SARWARAN PRIMARY SCHOOL
UNDER THE COMMANDER'S EMERGENCY RESPONSE PROGRAM
ERBIL, IRAQ

SIGIR PA-08-120
APRIL 21, 2008

SUBJECT: Report on Project Assessment of the Sarwaran Primary School, Erbil, Iraq (Report Number SIGIR PA-08-120)

Site Photo 9. Corrective actions subsequent to site visit to recess and cover receptacle. Portion of receptacle obscured. (Photo courtesy of MND-NE).

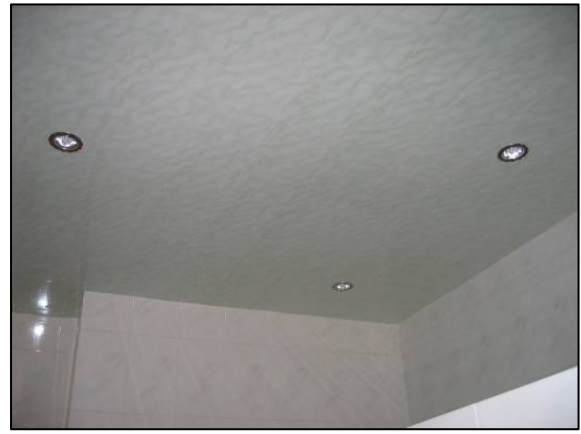
Electrical receptacles installed in the computer room floor were not covered, making them susceptible to being filled with dirt and stepped on. The MND-NE project engineer said that they were contracting for a five centimeter (cm) false floor to cover the receptacles. Site Photo 8 shows an uncovered receptacle at Sarwaran filled with dirt at the time of the site visit.

We observed that the same design was being used at the Binaslawas School, which we inspected later that day (SIGIR PA-08-121). The Binaslawas contractor was using a higher quality receptacle with a plastic cover. We recommended the receptacles be replaced with better quality coverings similar to those used at Binaslawas. Site Photo 9 shows the corrective action taken to recess the receptacle subsequent to SIGIR's site visit.
